1	INC. DCN ISID2-029C-3 PER DCR 89-0042 AND DCN ISID2-029C-4 PER DCR 90-1766	SBW	INITIALS ON FILE
2	INC. DCN ISID2-029C-2 PER DCR 97-1047		INITIALS ON FILE
3	INC. DCN ISID2-029C-1 FOR DCR 91-001		INITIALS ON FILE
4	ISSUED FOR SECOND 10 YEAR ISI PROGRAM	LPM TRM BUC	TWB MOP ECC
NO.	DATE	BY	CHKD. SUPER. ENGR. MOD.
SCALE: N.T.S.	DESIGNED	DRAWN: CB	DATE
<b>DAVIS-BESSE NUCLEAR POWER STATION</b>			
UNIT NO. 1			
THE TOLEDO EDISON COMPANY			
INSERVICE INSPECTION DIAGRAM			
CONTAINMENT AND PENETRATION ROOMS			
SHEET 2			
DRAWING NO.		REV.	
ISID2-029C		3

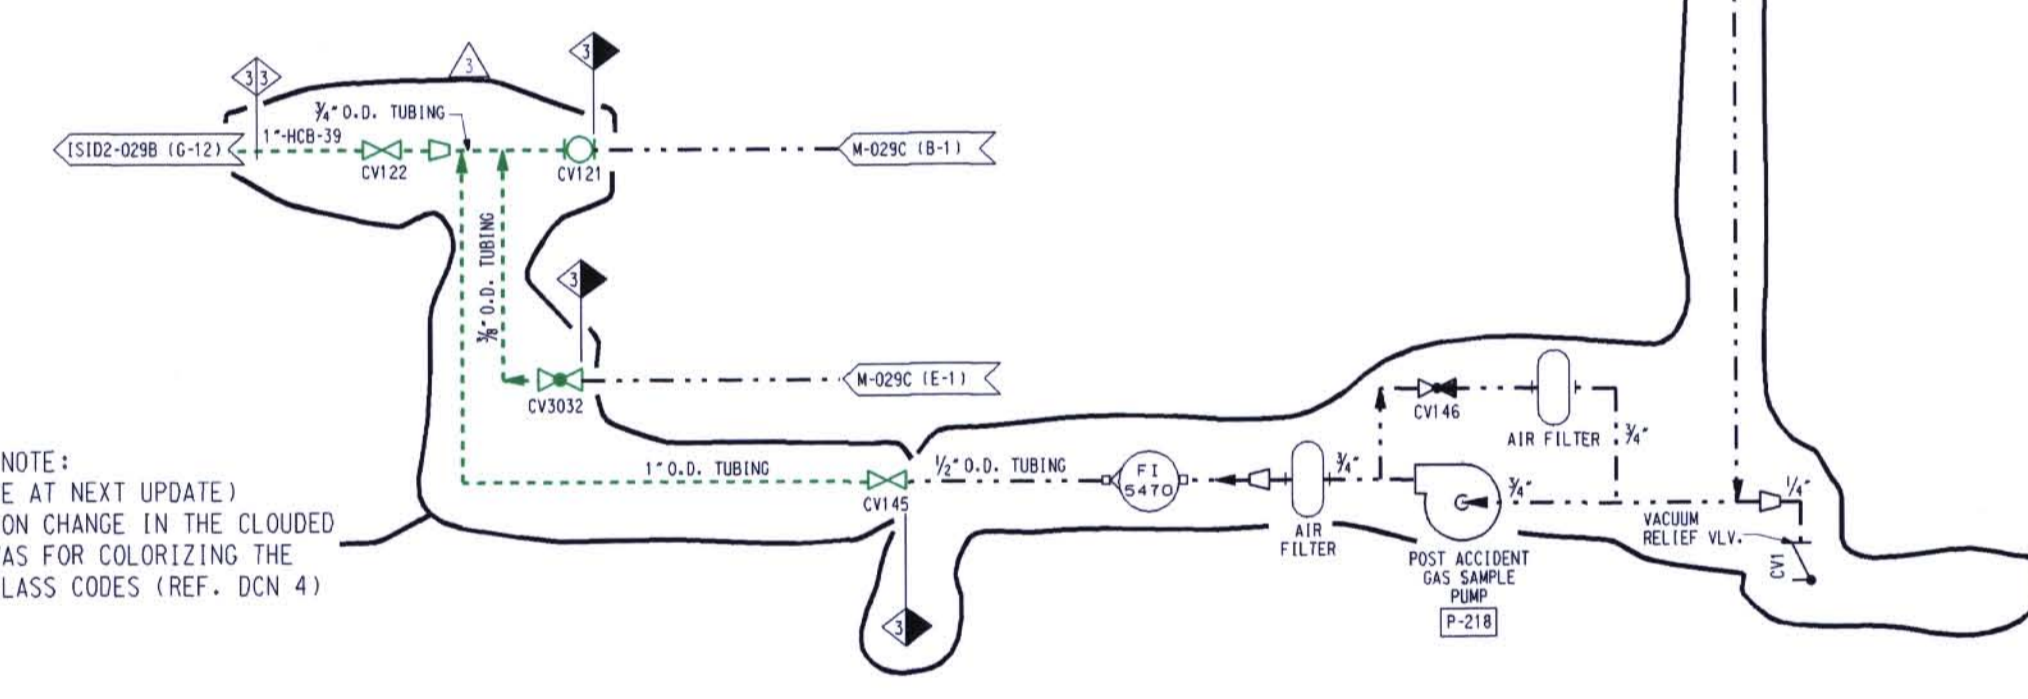
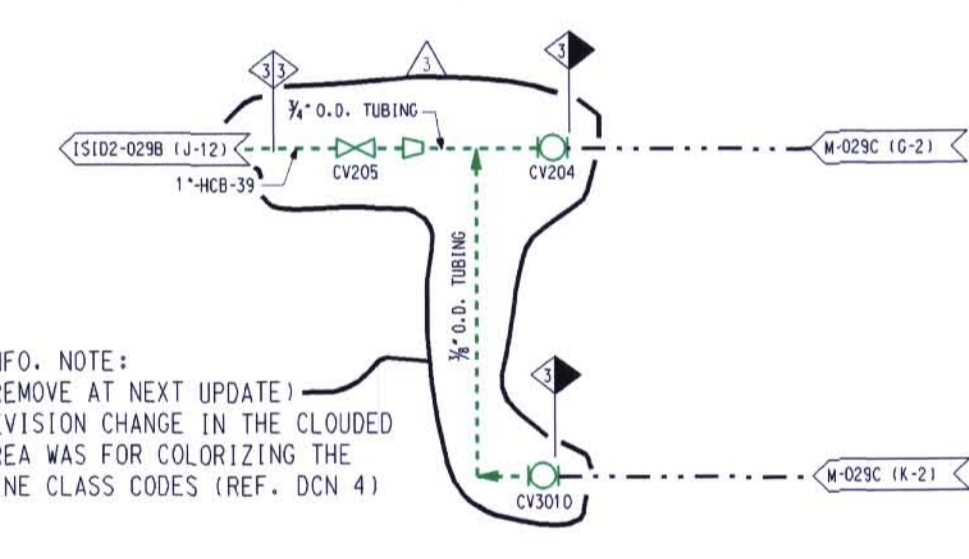
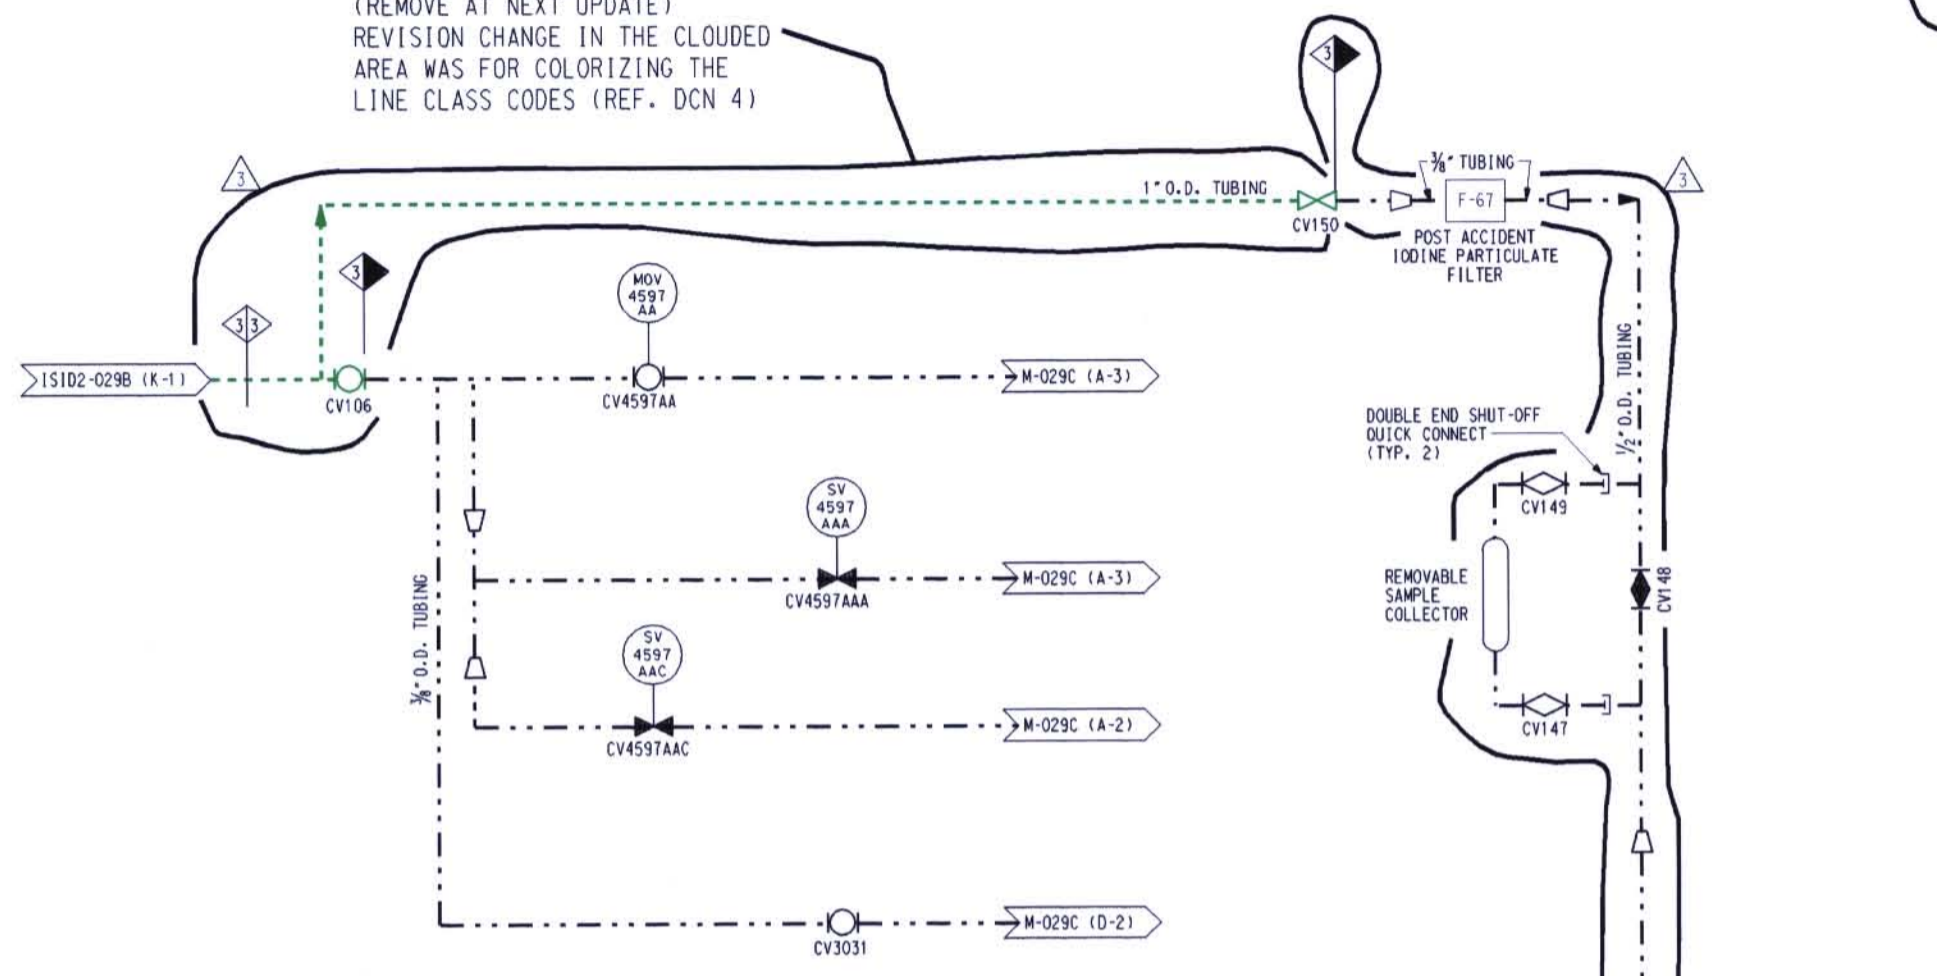
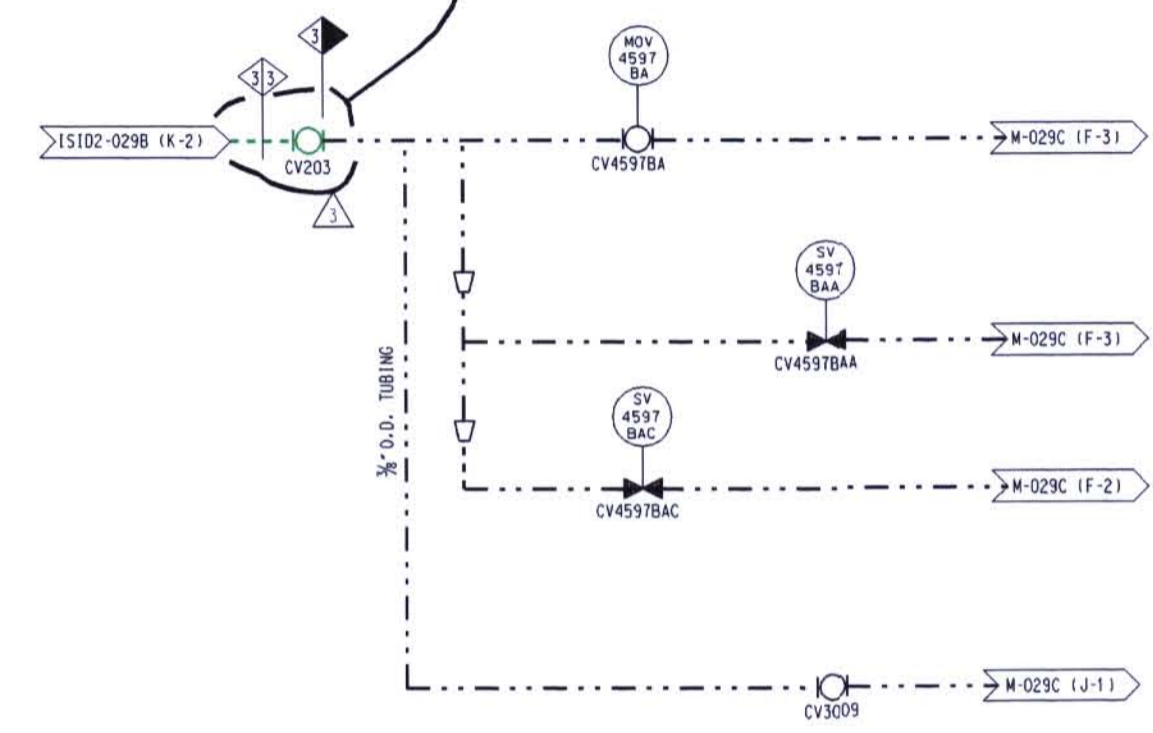
INFO. NOTE:  
(REMOVE AT NEXT UPDATE)  
REVISION CHANGE IN THE CLOUDED  
AREA WAS FOR COLORIZING THE  
LINE CLASS CODES (REF. DCN 4)

INFO. NOTE:  
(REMOVE AT NEXT UPDATE)  
REVISION CHANGE IN THE CLOUDED  
AREA WAS FOR COLORIZING THE  
LINE CLASS CODES (REF. DCN 4)

INFO. NOTE:  
(REMOVE AT NEXT UPDATE)  
REVISION CHANGE IN THE CLOUDED  
AREA WAS FOR COLORIZING THE  
LINE CLASS CODES (REF. DCN 4)

INFO. NOTE:  
(REMOVE AT NEXT UPDATE)  
REVISION CHANGE IN THE CLOUDED  
AREA WAS FOR COLORIZING THE  
LINE CLASS CODES (REF. DCN 4)
